Title			
M Project rev5 SST441			
Size C	Document Number <Doc>	Rev <Rev Code>	
Date	Friday, May 21, 2004	Sheet	1 of 1

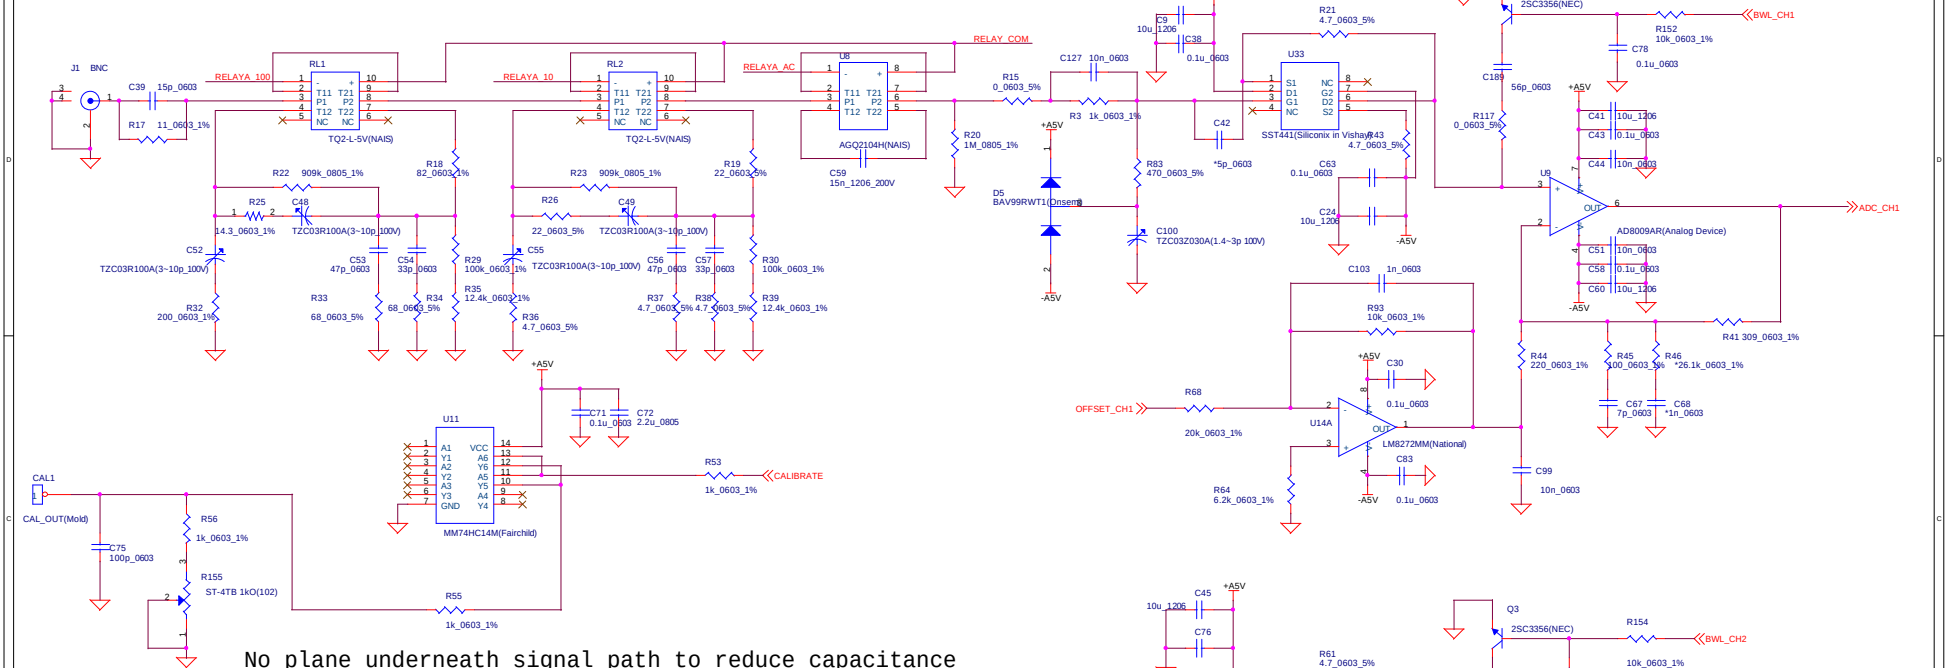
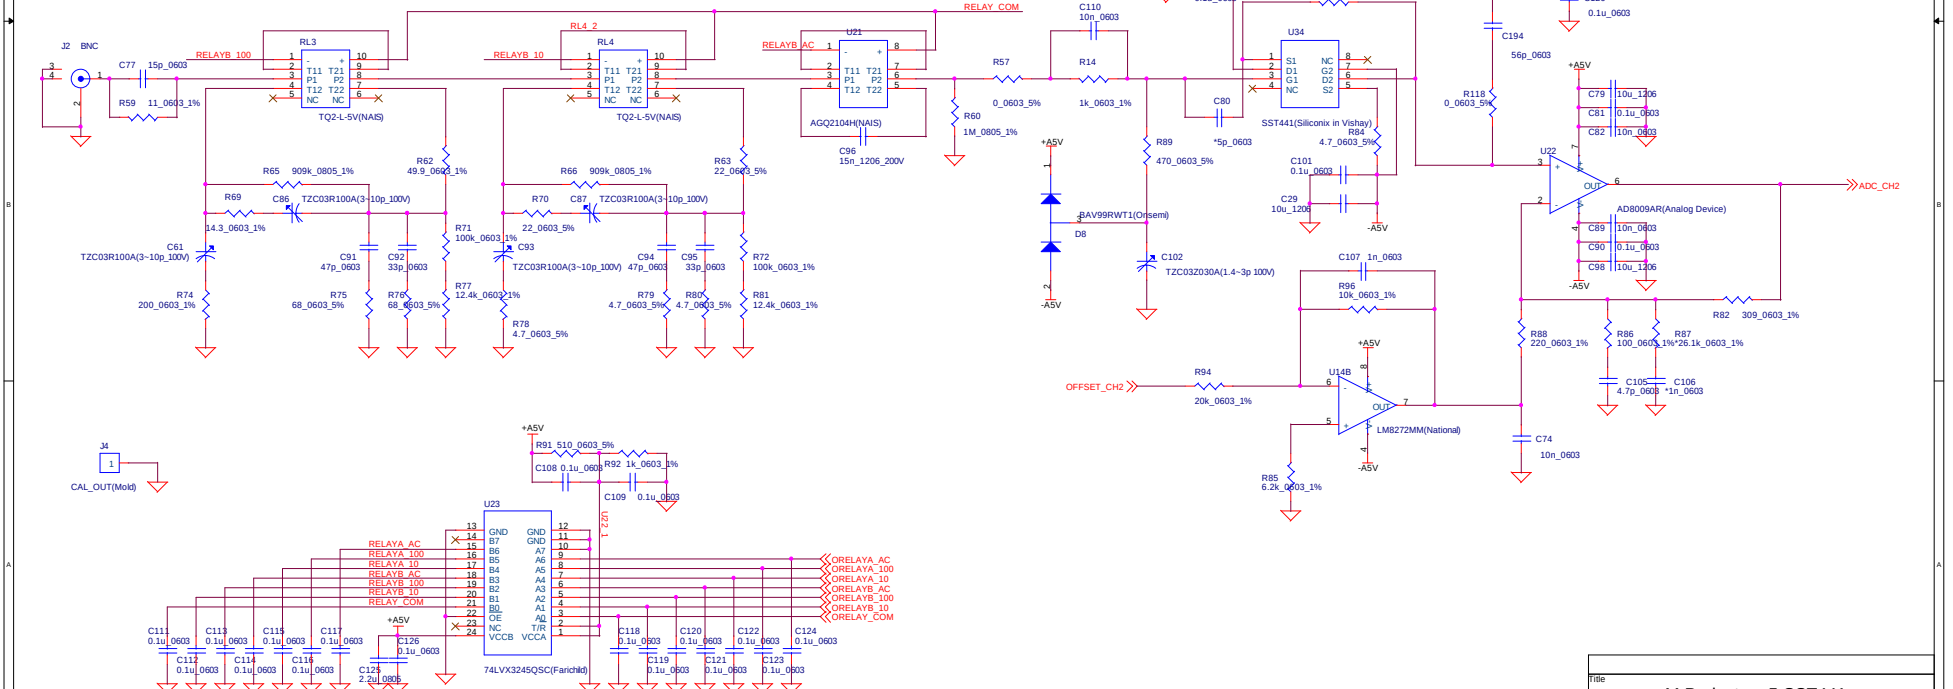
No plane underneath signal path to reduce capacitance

No plane underneath signal path to reduce capacitance
